GARD response to

**Ofwat's Consultation on
Draft Ofwat Gate 2 Decision**

11th May 2023

GARD Review of Draft Ofwat Gate 2 Decisions

Figure 3 - RAPID and GARD quality scores for Abingdon reservoir Gate 2 report

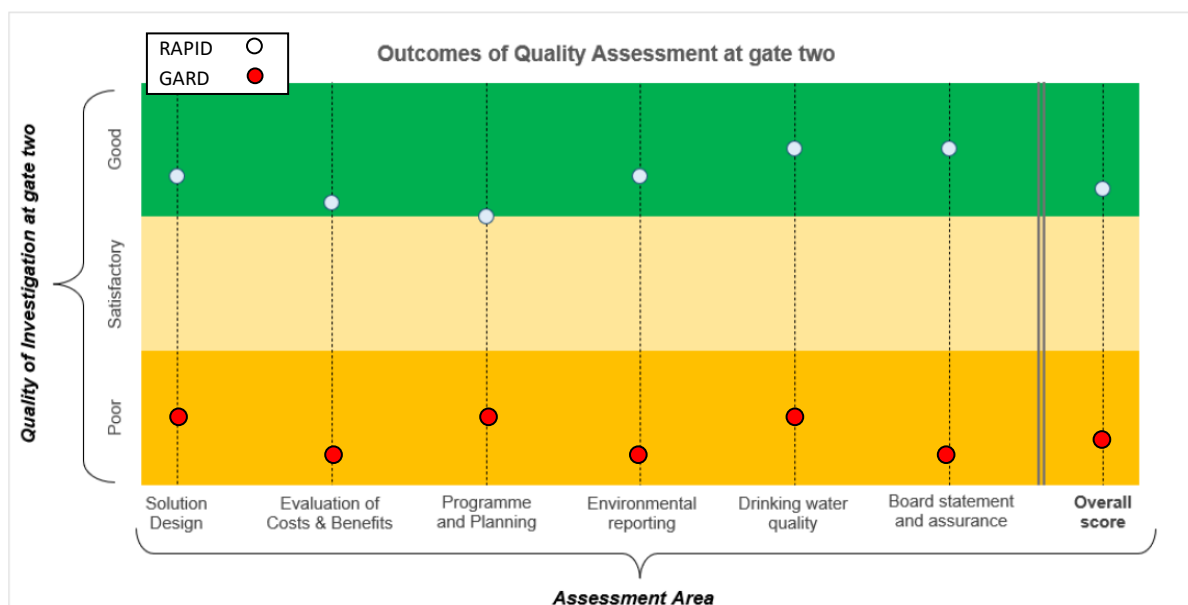
We strongly disagree with Ofwat’s assessment, marking the Gate 2 report as poor in all the assessed categories, as shown in Figure 3. In the following sections, we have provided brief comments on each of these categories, with supporting evidence in Appendices.

Figure 7 - Abingdon reservoir in artificially extended historic 1934 drought

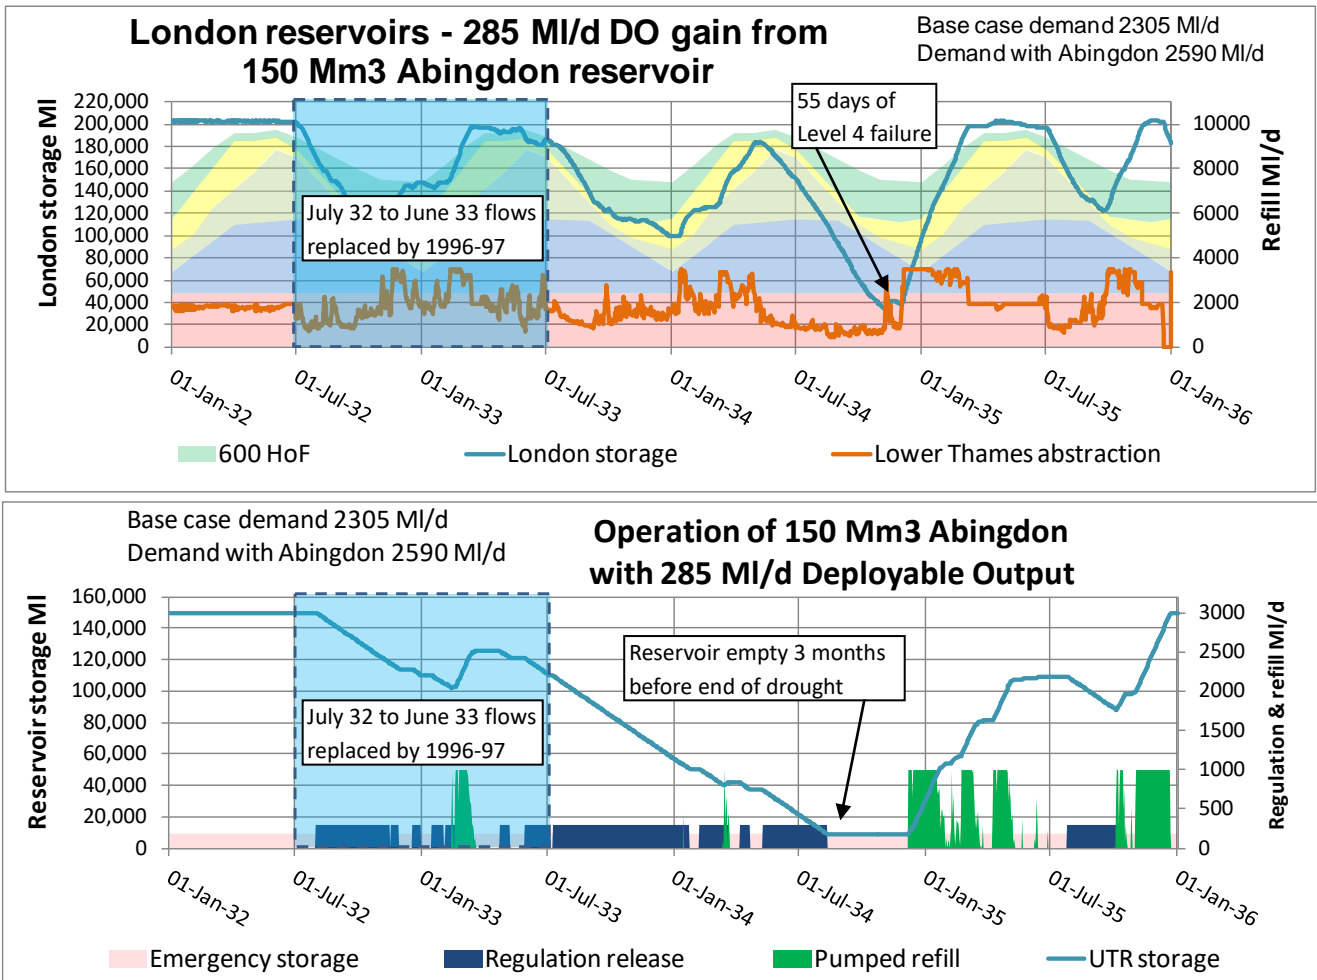
3. However, although the Culham MRF error does not appear to have a big impact on Abingdon reservoir deployable output, it can greatly affect the speed of reservoir refilling after droughts. For some of the relatively few droughts in the stochastic record which are not versions of the 1976 drought, GARD's modelling shows that Abingdon reservoir is less than half full at the start of the next summer and vulnerable to failure if another dry summer follows – similar to the failure shown in Figure 7.

The deployable output of Abingdon reservoir will be a lot less than shown in the table above, perhaps only half these values, when proper consideration has been given to the likelihood of a sequence of dry years which prevent the reservoir from being full at the start of a major drought or delay its refilling after a major drought, as shown by the example in Figure 7.

Figure 8 - Thames Water's pre-construction programme for Abingdon reservoir

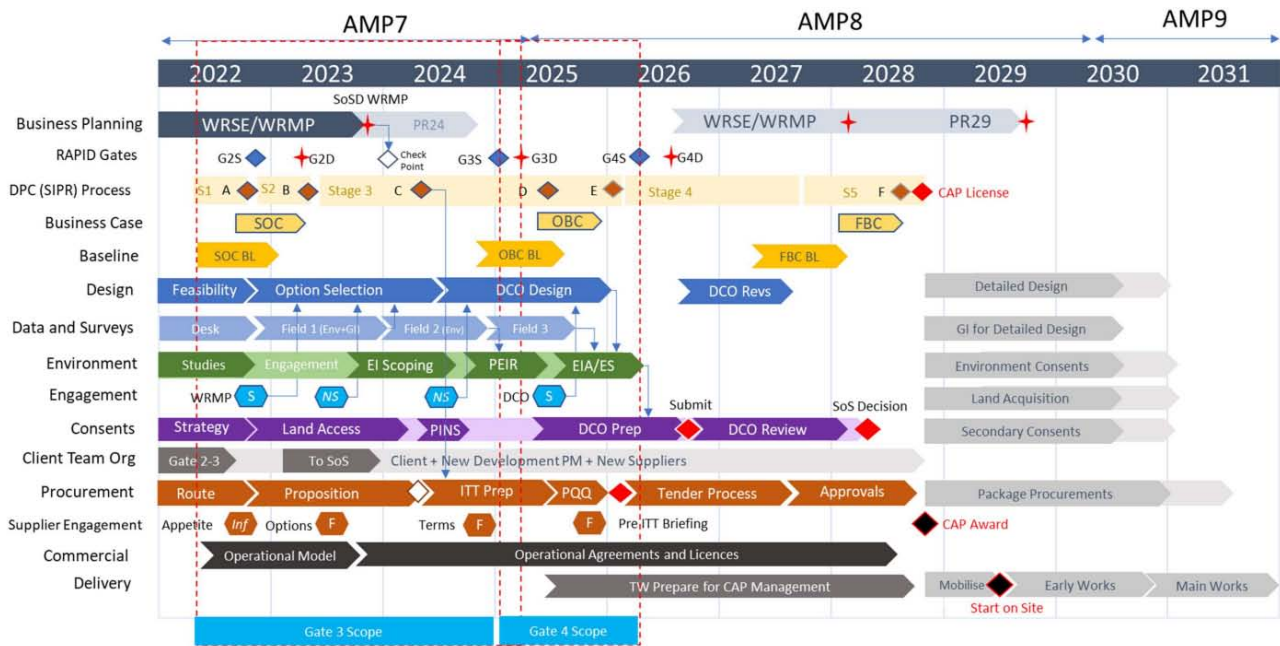
geotechnical investigations, including a trial borrow pit and embankment, before the pre-tender design and the start of the tender process. We can see no evidence of planning of the geotechnical investigations, either in the SESRO Gate 2 reports or on the programme shown in Figure 8.

Figure 11- Proportion of Abingdon reservoir releases in river flow downstream

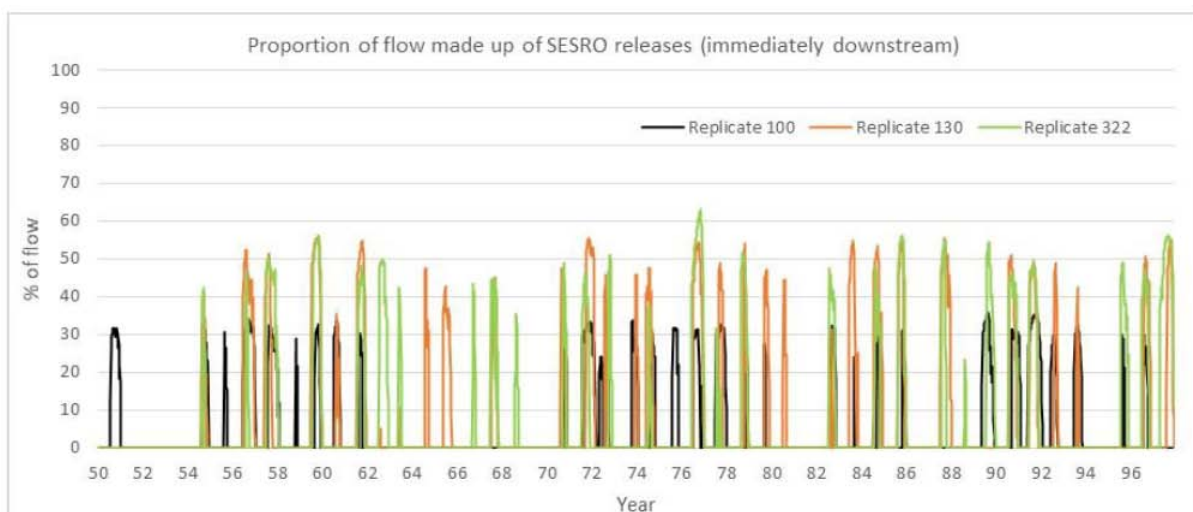
"Although SESRO will modify flows, the bulk of the river flow at most times will continue to be existing natural river flow (Figure 2.2). Even when fully operational, SESRO will rarely make up more than 50% of the flow immediately downstream of the outfall, and this proportion will diminish downstream as tributaries add more flow. Consequently, the water quality risk in the River Thames will for many chemicals remain much the same as before."

We do not know how the figure above was generated, but it is clear from the NRFA web-site

Figure 13 - RAPID and GARD quality scores for Severn Thames Transfer Gate 2 report

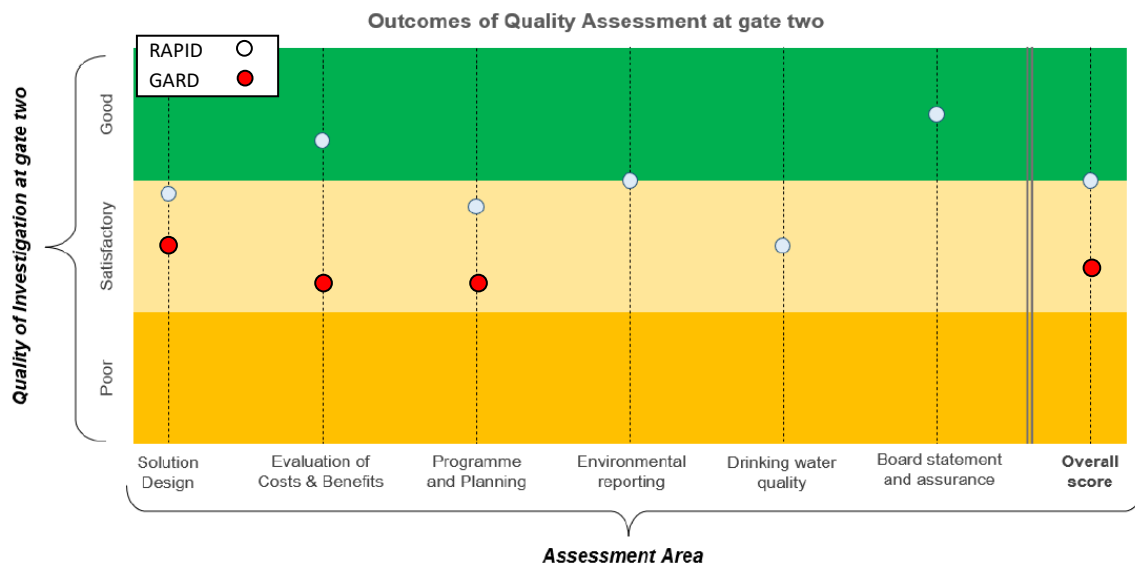
As shown on Figure 13, Ofwat have rated the solution design as ‘Satisfactory’ rather than ‘Good’, explained as follows:

Figure 15 - Operational carbon budgets for STT Deerhurst interconnector options

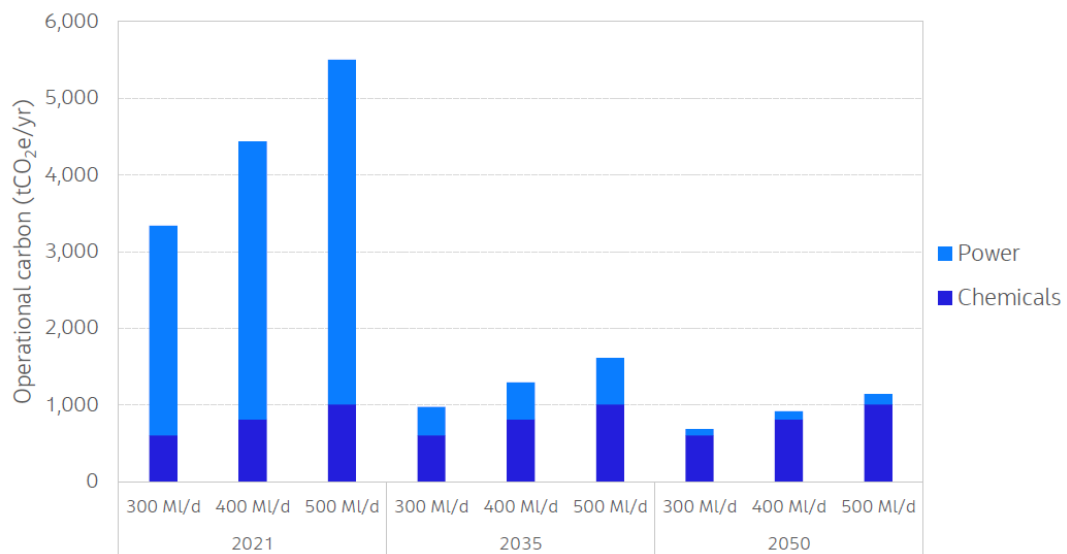
- The most important problem however, is the ***difference in assumed Operational Start date***. This has already been noted as affecting cost comparisons, but as Figure 15 shows, there is a huge difference in Opex carbon if the Deerhurst connector had started operation in 2021, compared to an operational start date of 2035 (the earliest feasible current start date). In fact, this distorts the whole evaluation in the STT Design Report (table 6.2) the Opex carbon for the 300 MI/d Deerhurst option is

quoted as **139,258 tCO₂Eq**. This figure cannot possibly be derived from 70-80 years of operation with the Figure 15 yearly Opex carbon. By 2035 the Opex carbon for Deerhurst is less than 1000 tCO₂eq per annum and reduces to around 600 tCO₂eq by 2050.

Figure 17 - Typical operational use of the 120 MI/d Thames to Southern transfer

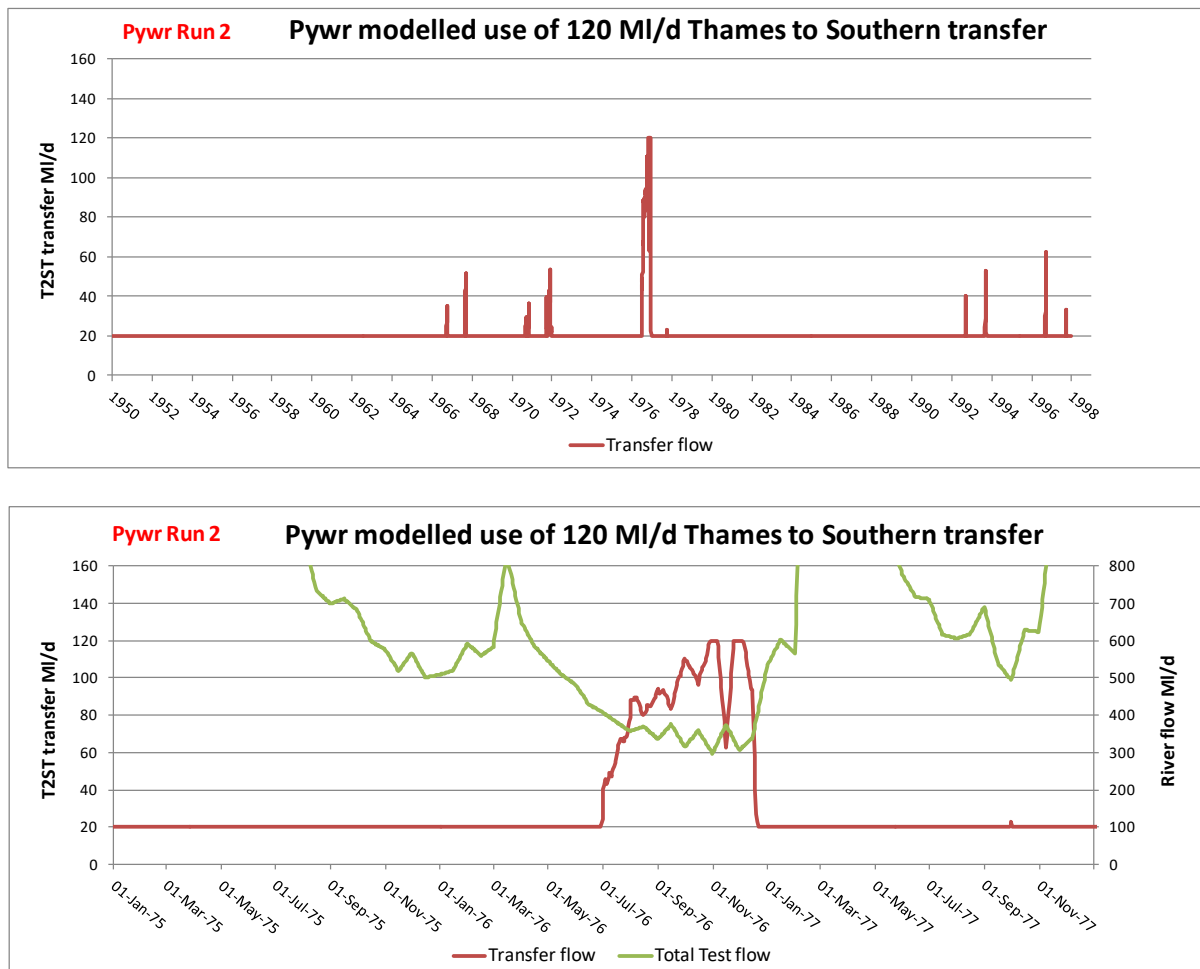
In major drought years, like 1976 in the example shown in the lower plot in Figure 17, the transfer could run for 6 months or more, triggered to comply with a total Test hands-off flow of 355 MI/d, and peaking at the 120 MI/d capacity for short periods. However, although the Pywr modelling shows drought use about once in 5 years on average, usually this will be for a relatively short period and at much less than the 120 MI/d capacity.

The plots in Figure 17 are based on stochastic river flow data. We propose that the credibility of the modelled frequency and amount of usage should be tested by comparison with gauged flow records and historic frequency of triggering the drought permits.

Figure K1 - Cross-section of reservoir showing borrow pit

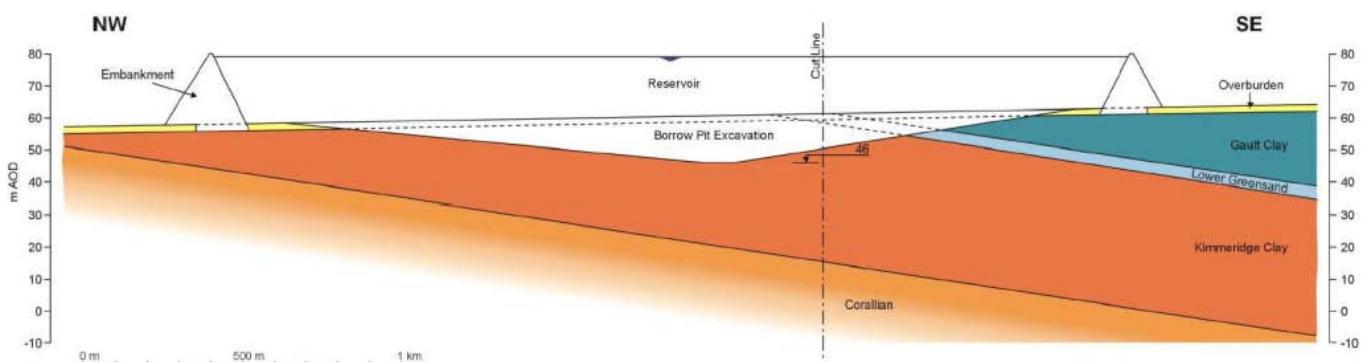
Therefore there should be a minimum average depth of 5m of water when the emergency storage is empty. Figure 21 shows a cross-section of the reservoir and borrow pit¹⁹¹:
